TDG Ref: 12834.001
27 February 2015

North Kumutoto Precinct Project
Response to WCC Request for Further Information

Council's Request dated 5 February 2015 seeks further information and clarification on a number of urban design, traffic and related matters.

Site 9
Car Park

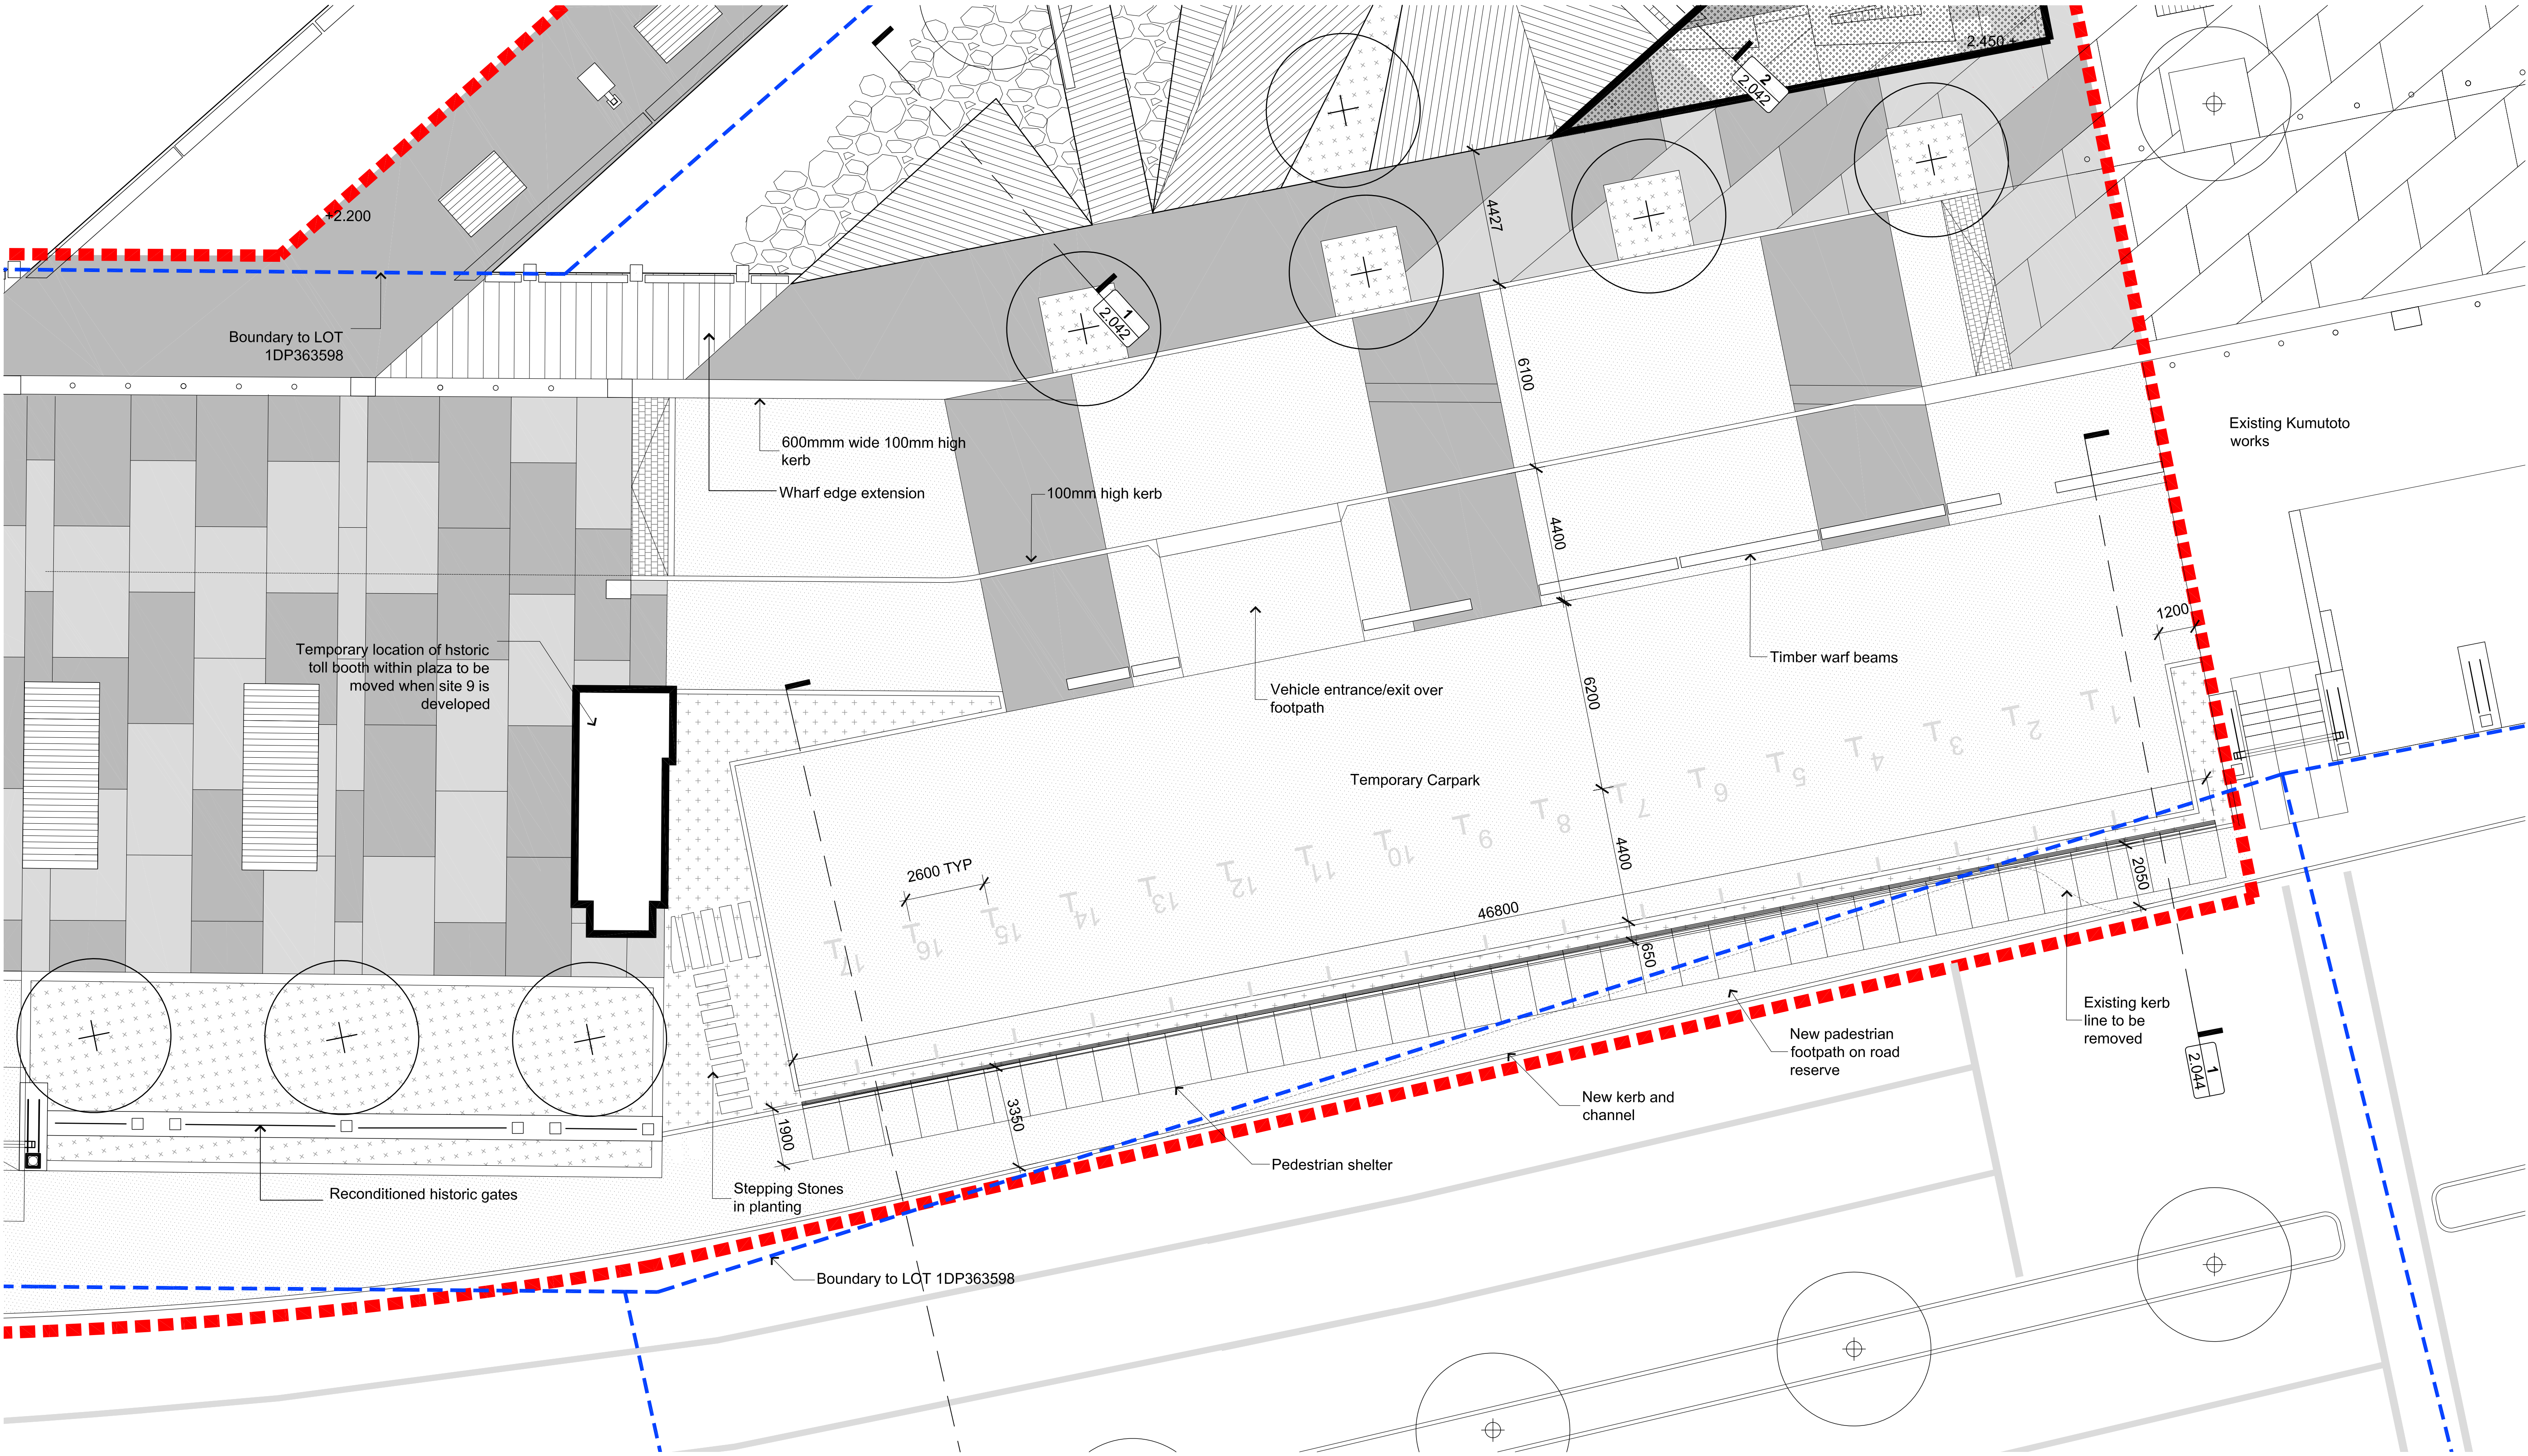
- 11.** *Please clarify whether the new footpath to be provided alongside Site 9 (between the Whitmore Street gates and Waring Taylor Street) will be within legal road or within a private site (please indicate the site boundary of the proposed plan).*

- 16.** *Please provide details of the altered car park layout for Site 9 (including any subsequent hard/soft landscaping changes).*

Appendix B includes two plans with dimensions showing the intended footpath arrangements along Customhouse Quay, and also showing the property boundary (refer Drawing Numbers 1.044 and 1.046 prepared by Isthmus).

Drawing Number 1.046 prepared by Isthmus and included in Appendix B is a scaled plan with dimensions showing the carpark layout, including a stall depth of 4.4m, an overhang of 0.65m and an aisle width of 6.2m.

Kumutoto Laneway Section

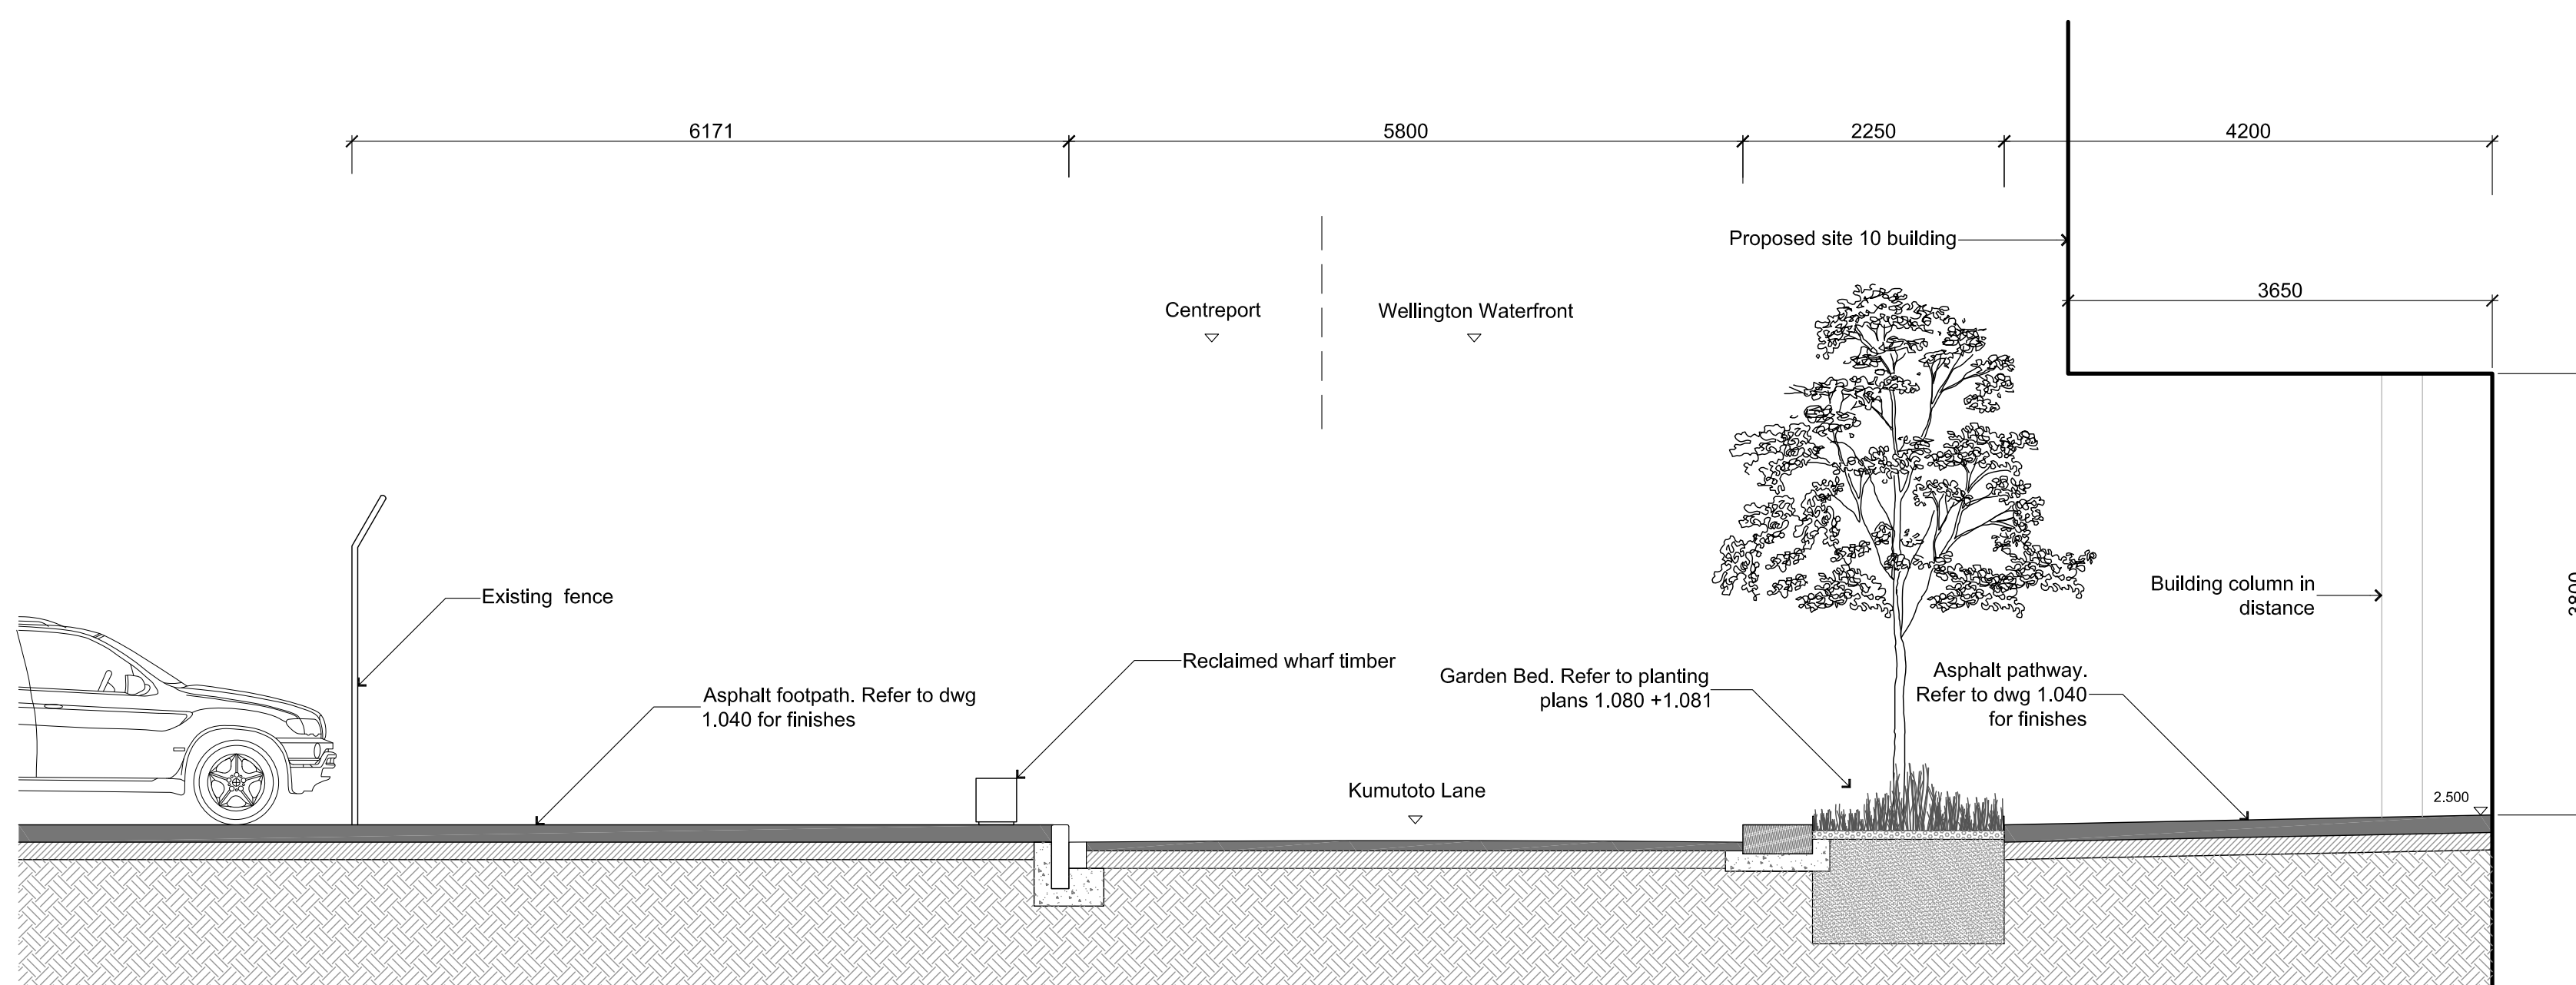
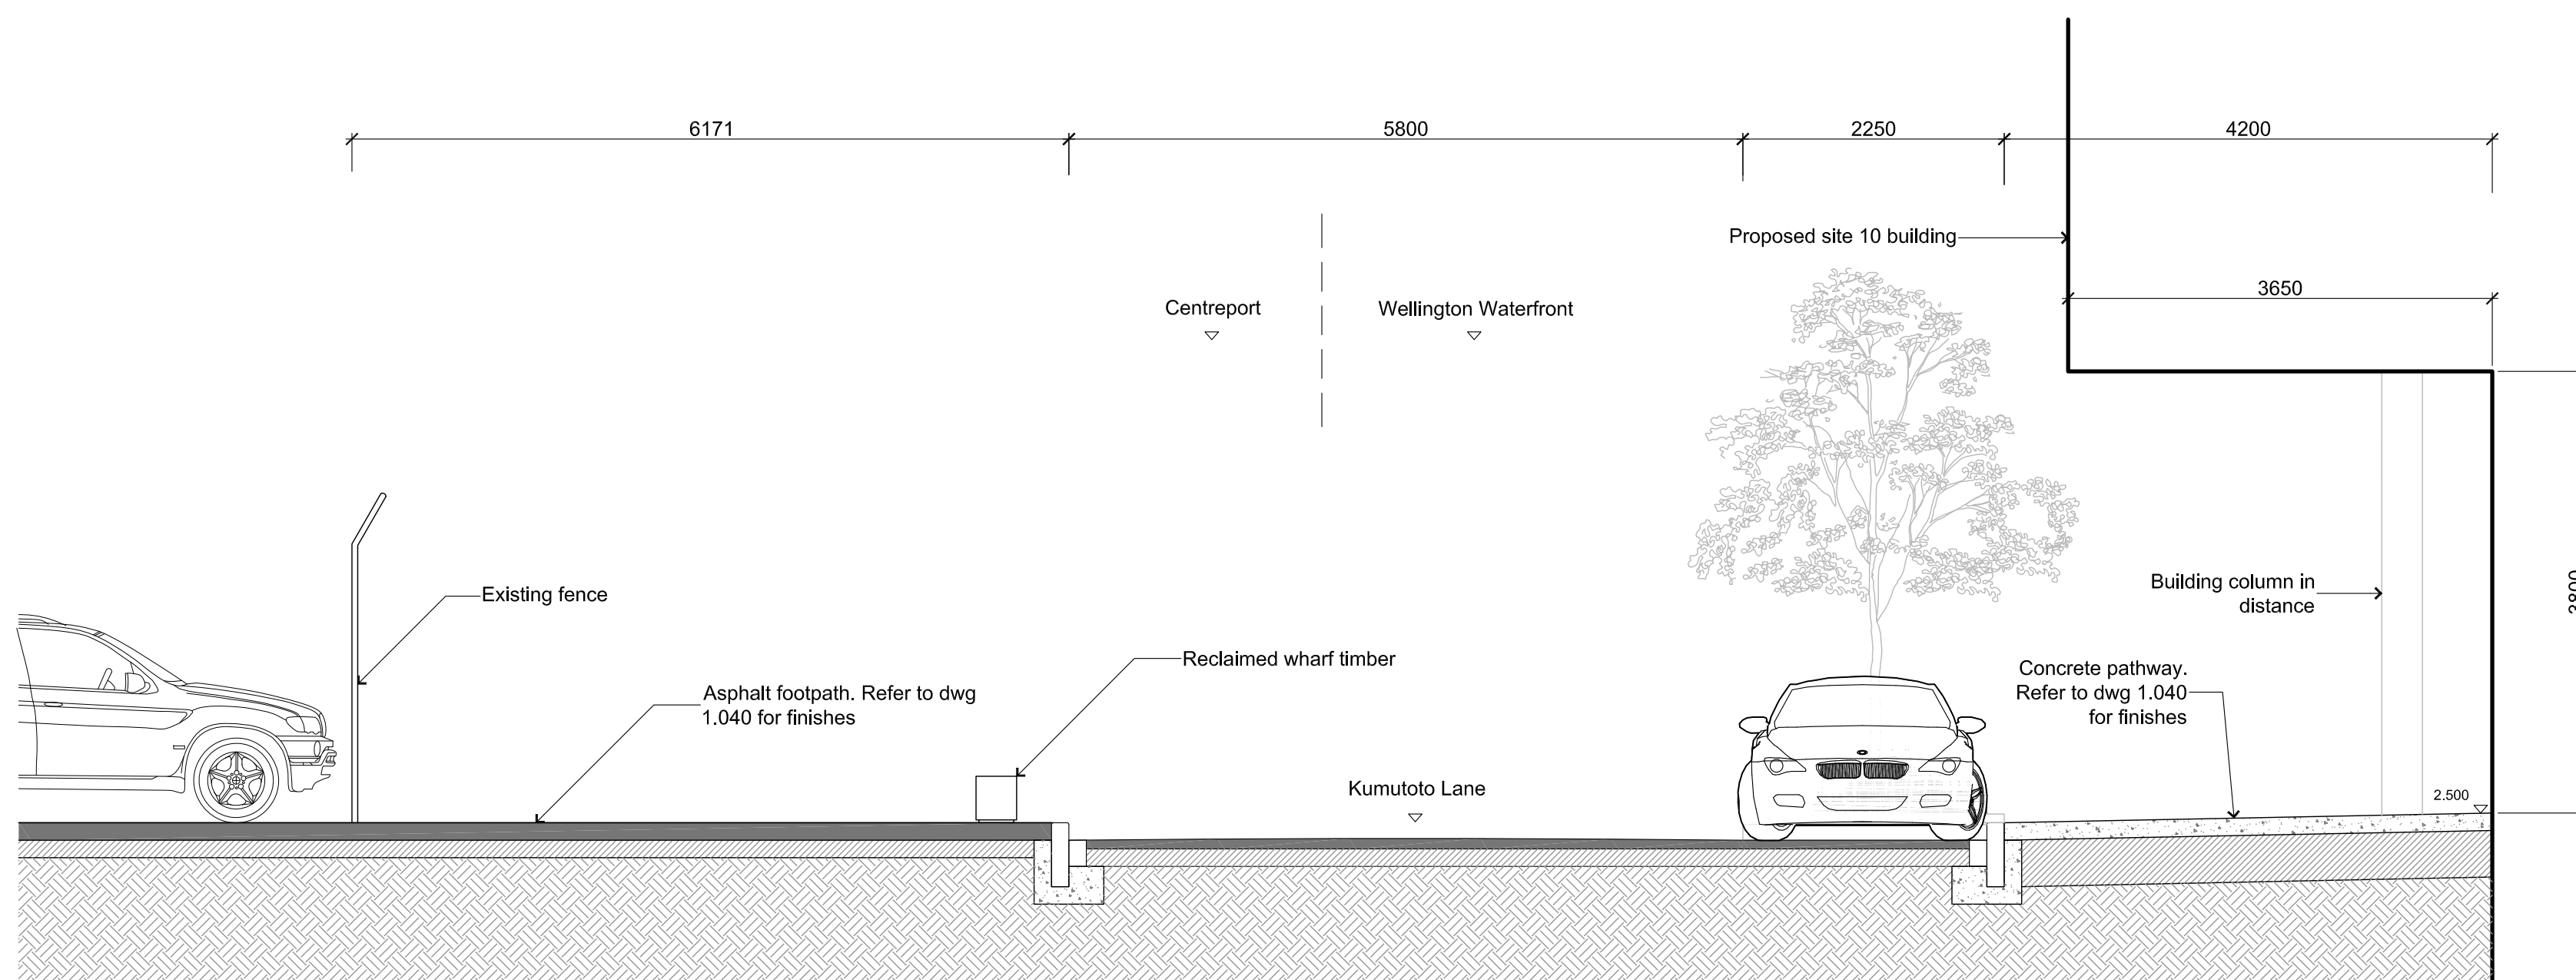
- 15.** *Please provide details of how any parallel movements from the adjoining Centreport Land will interact with the new shared access lane.*

There is no intention to provide two parallel roadways to the rear of Shed 21 and Site 10. Rather, the existing laneway will shift westwards to the positions shown on the application plans, and the existing laneway space within Centreport land will be demarcated from the new Kumutoto Lane with timber beams, and available for pedestrians and cyclists.

The proposed arrangements are shown by the cross-sections included in Appendix E (refer Drawing Number 2.056 prepared by Isthmus).
